**CITY OF LAKEWOOD
PALMS PARK COMMUNITY CENTER IMPROVEMENTS PROJECT
PUBLIC WORKS PROJECT NO. 23-01**

ADDENDUM NO.1

DATE: MARCH 4, 2026

SHEET
G4-01

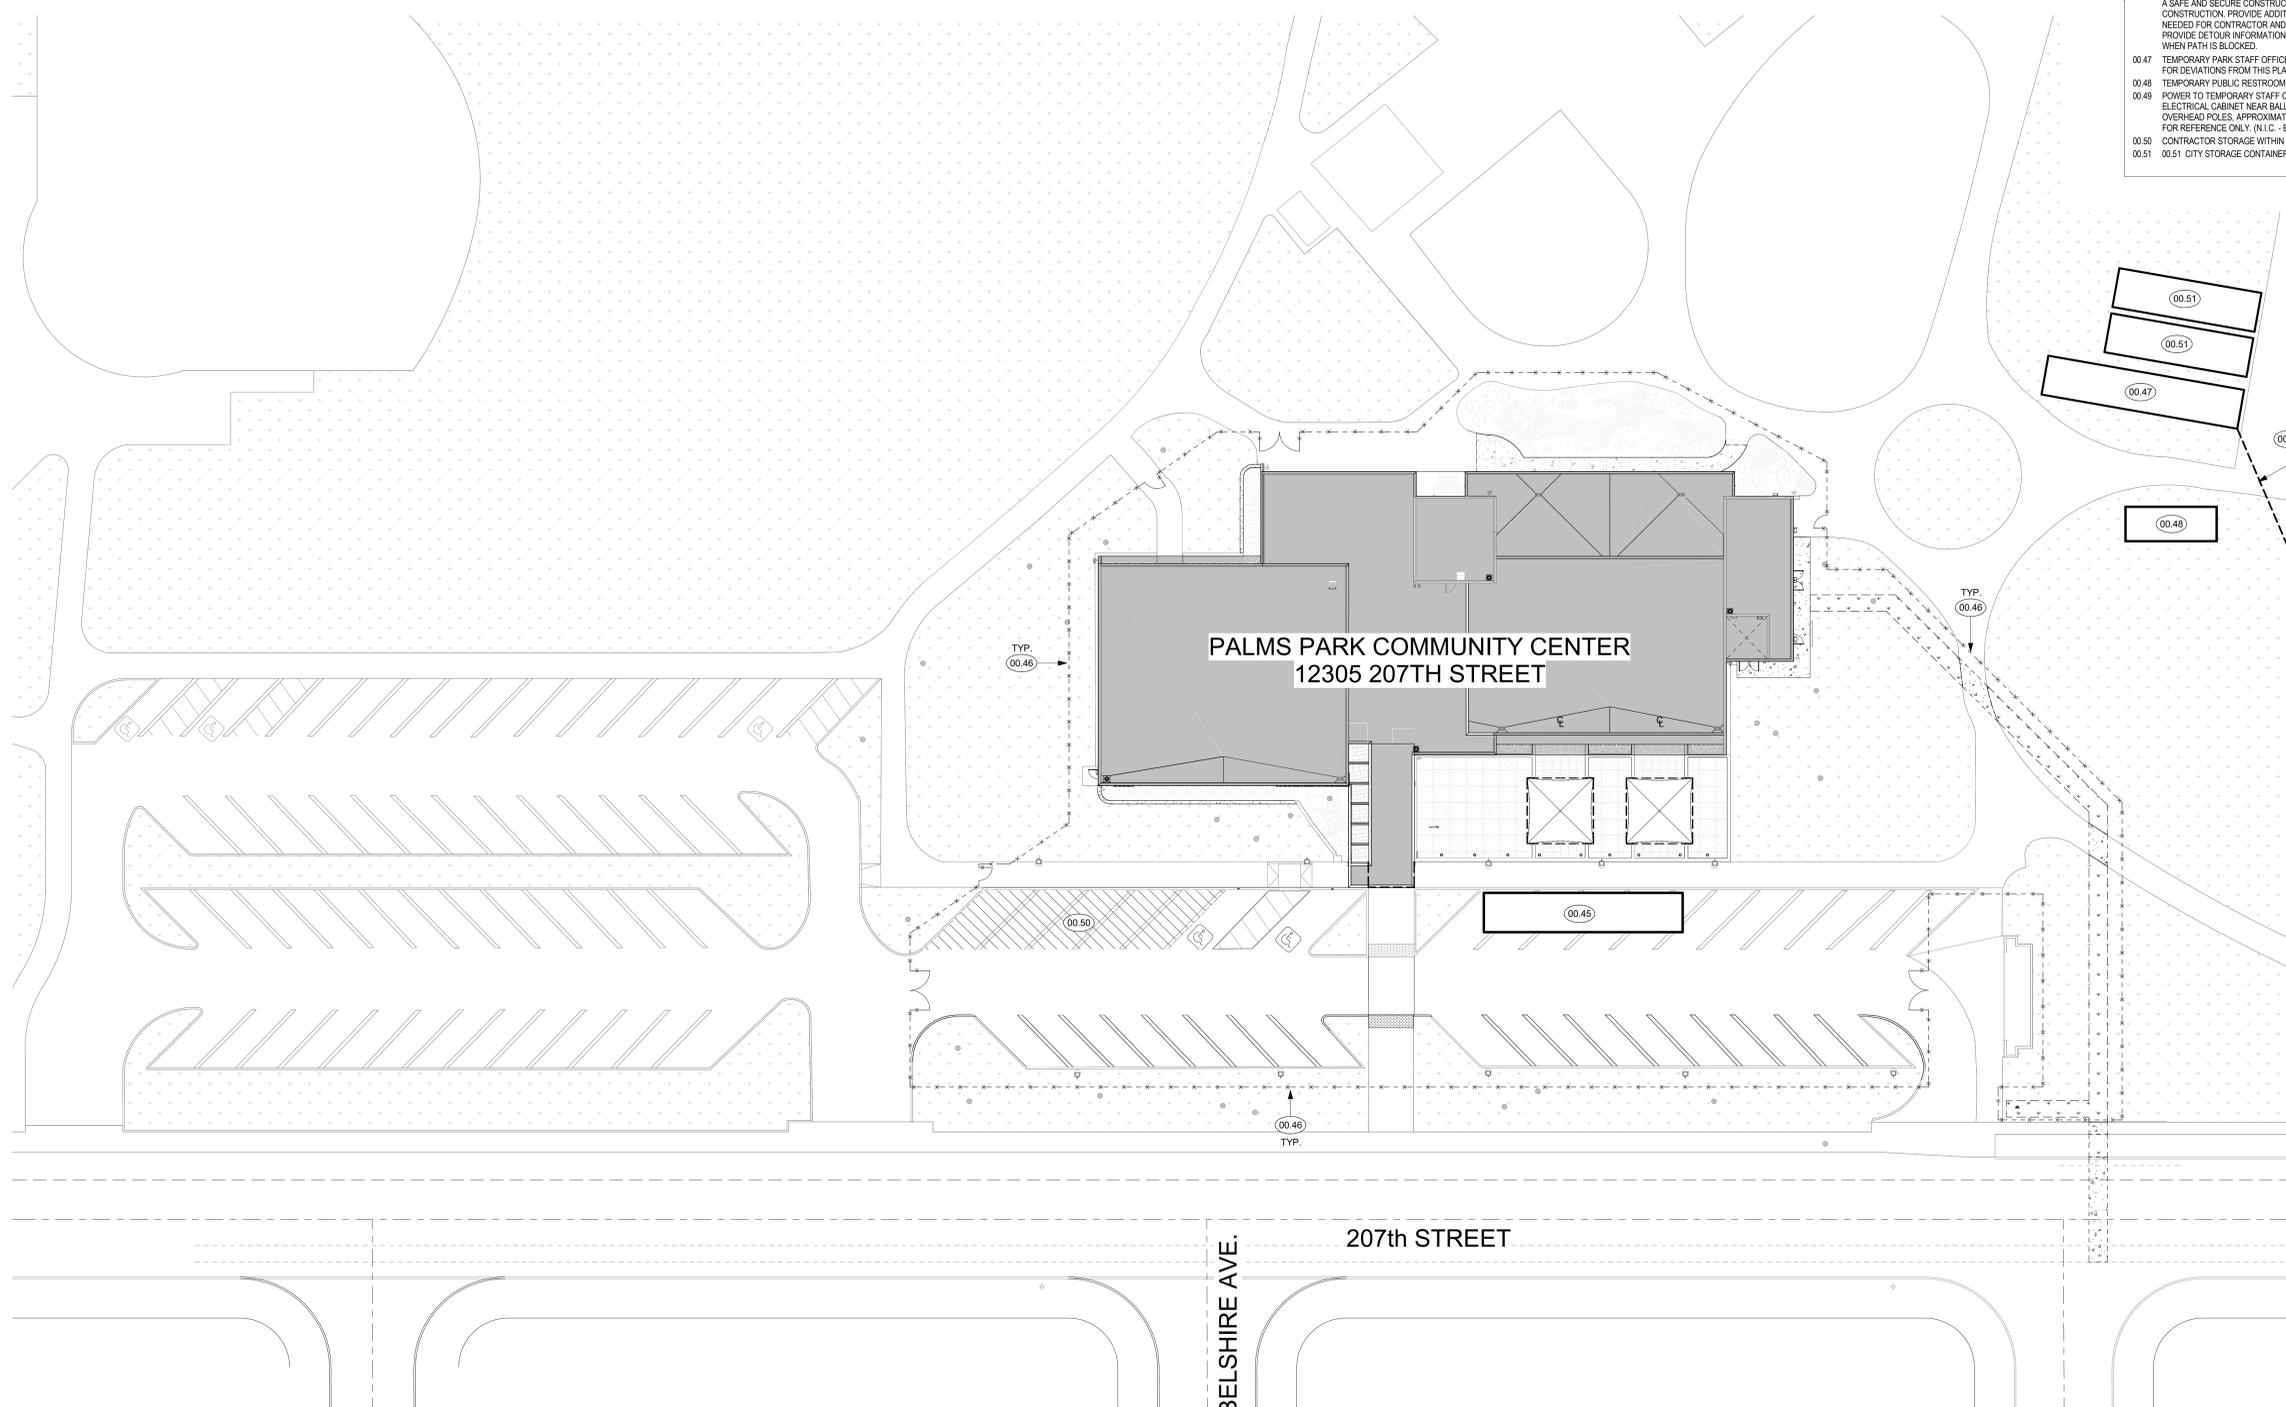
1. G0-01 – SHEET INDEX SYMBOLS AND ABBREVIATIONS
 - a. Added Contractor Staging Plan G4-01
2. G4-01 – CONTRACTOR STAGING PLAN
 - a. Added sheet
3. A0-00 – DEMOLITION SITE PLAN
 - a. Added an existing light
 - b. Add keynote for existing underground utility
 - c. Added existing utility cover and the keynote
 - d. Add keynote for existing concrete paving to remain
 - e. Move keynotes to right location
 - f. Keynote has been removed

A0-20

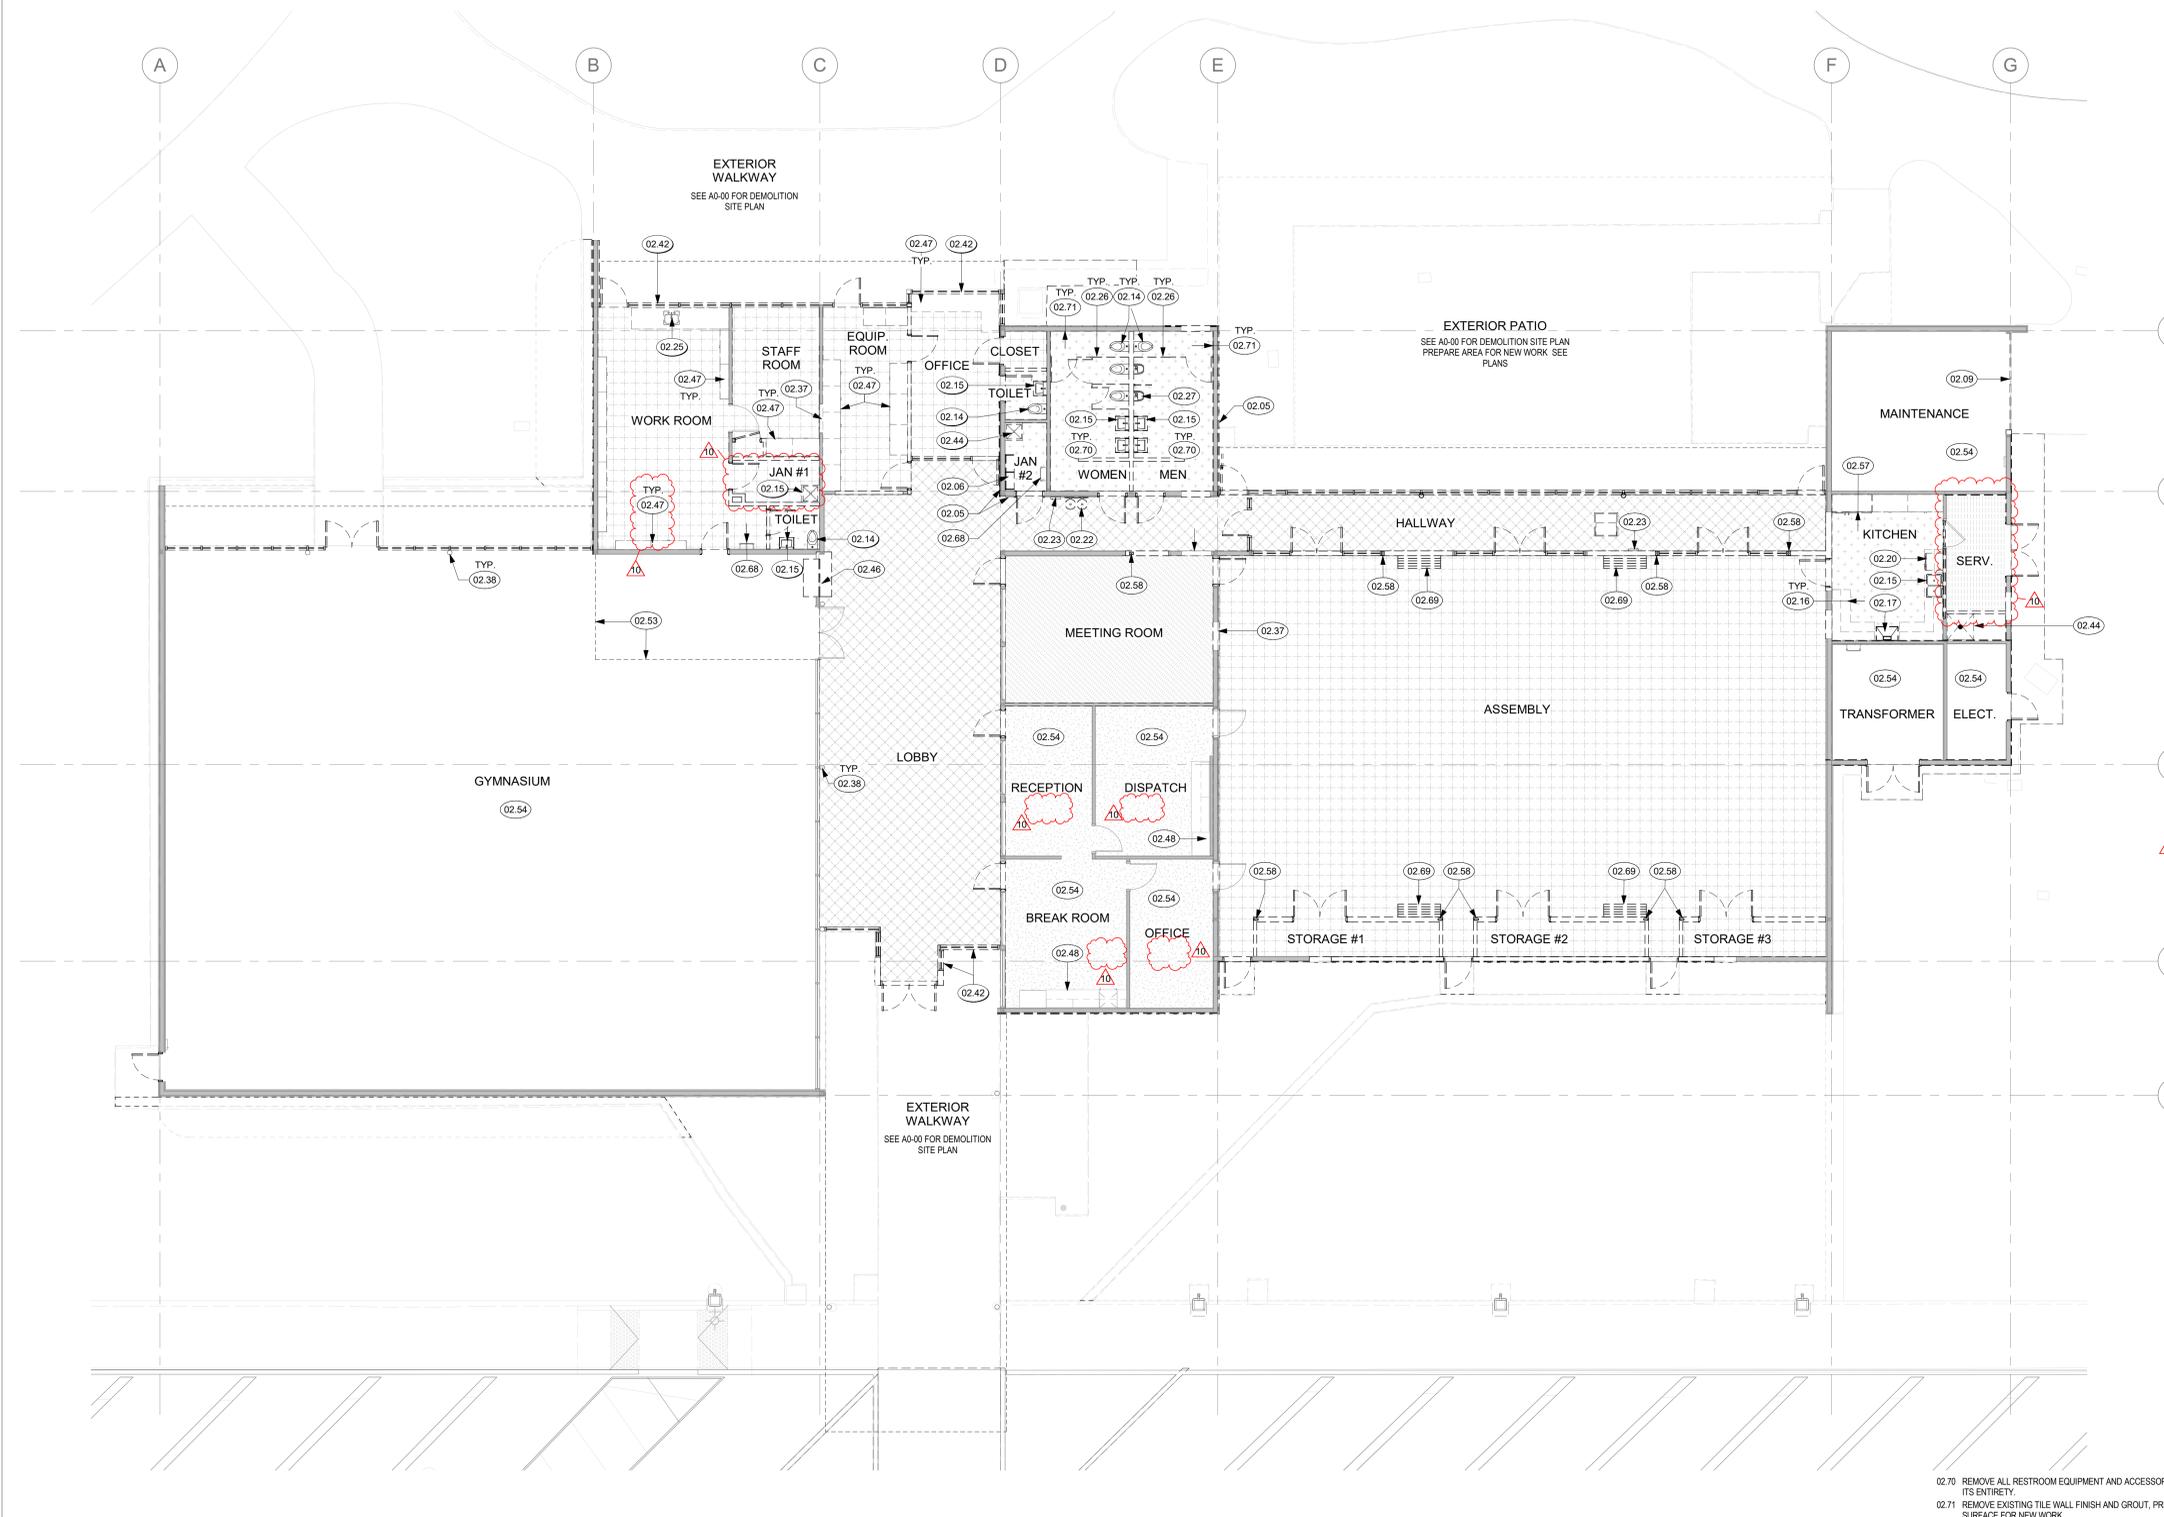
Q32 Per sheet A0-20, the rooms labeled "RECEPTION" and "DISPATCH" do not have any scope of work in them. Is keynote 02.98 still applicable? Can items remain and be protected/covered?

4. A0-20 – DEMOLITION FLOOR PLAN
 - a. Remove existing casework
 - b. Add new legend for demo concrete floor
 - c. Keynote 02.98 has been removed from rooms: Reception, Dispatch, Breakroom and Office
 - d. Demo existing vinyl tile flooring in the JAN #1
5. A0-30 – DEMOLITION REFLECTED CEILING PLAN
 - a. Change demo mechanical equipment in legend
 - b. Revised keynote for: Reception, Dispatch, Breakroom and Office
6. A0-50 – DEMOLITION EXTERIOR ELEVATIONS
 - a. Add keynote for selective demolition of exterior wall, prepare for new opening
7. A1-11 SITE PLAN
 - a. Add utility plate cover and keynote
8. A2-31 – FLOOR FINISH PLAN
 - a. Match graphic scale to the view scale
9. A5-11 – EXTERIOR ELEVATIONS
 - a. Added General Note #9 to include cleaning of brick masonry

SHEET
L3.1

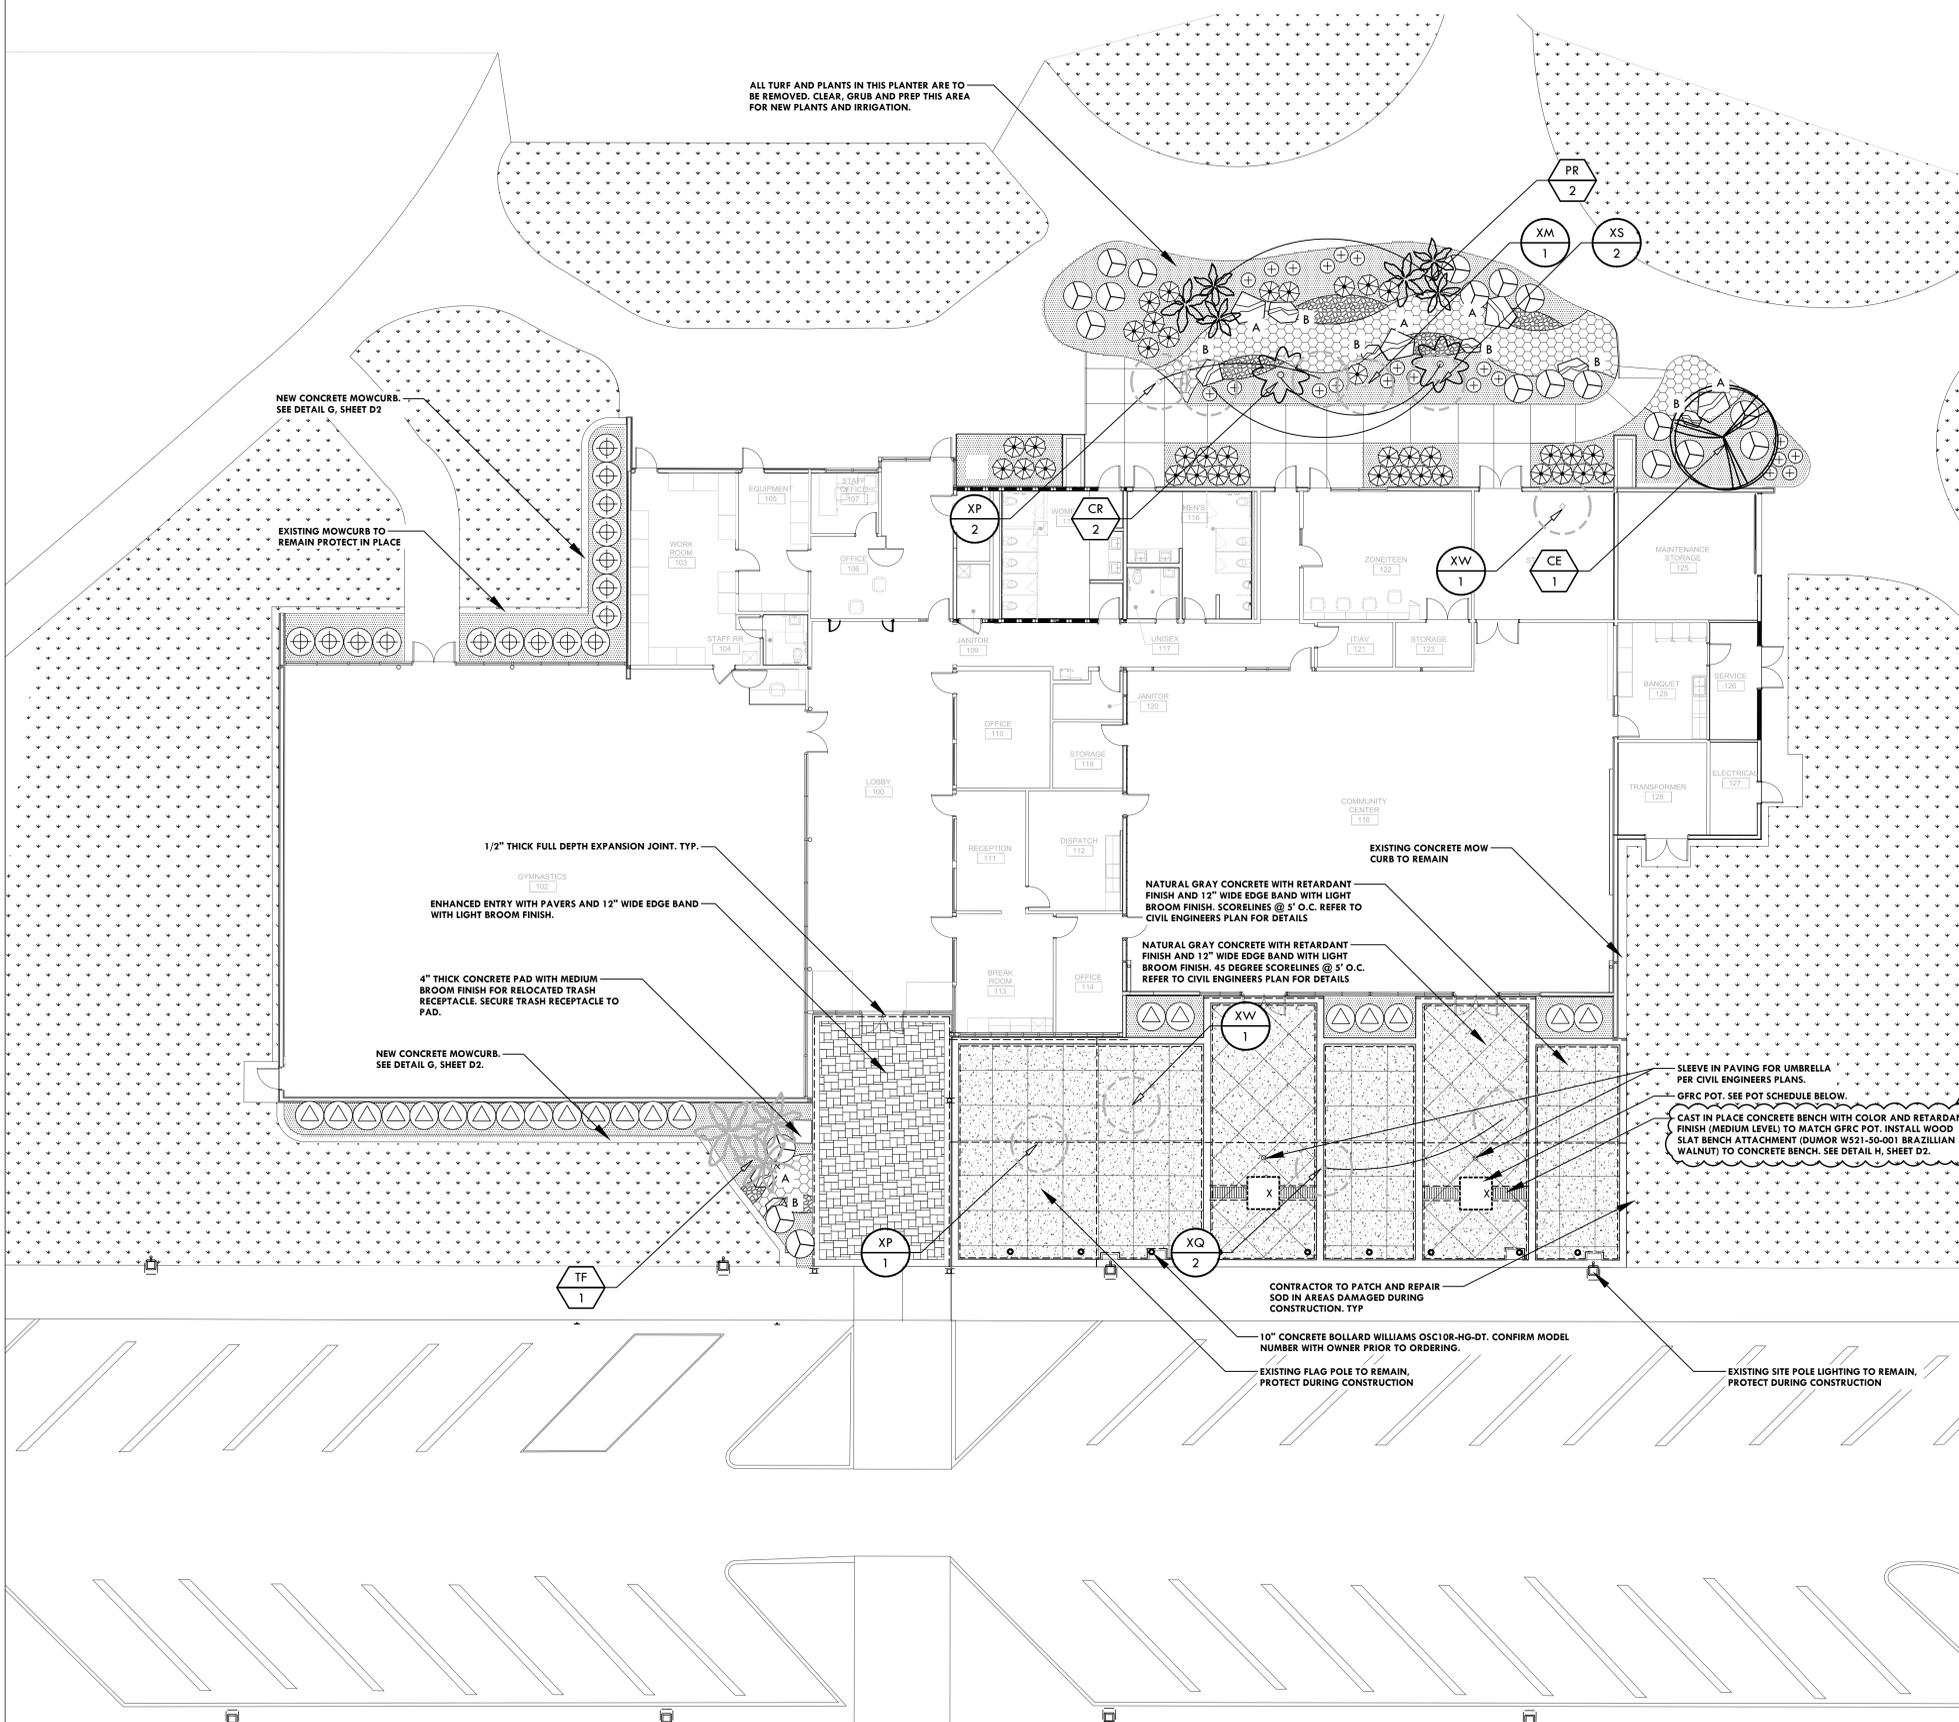
1. L3.1 – PLANTING PLAN
 - a. Revised notes for wood slat finish of bench
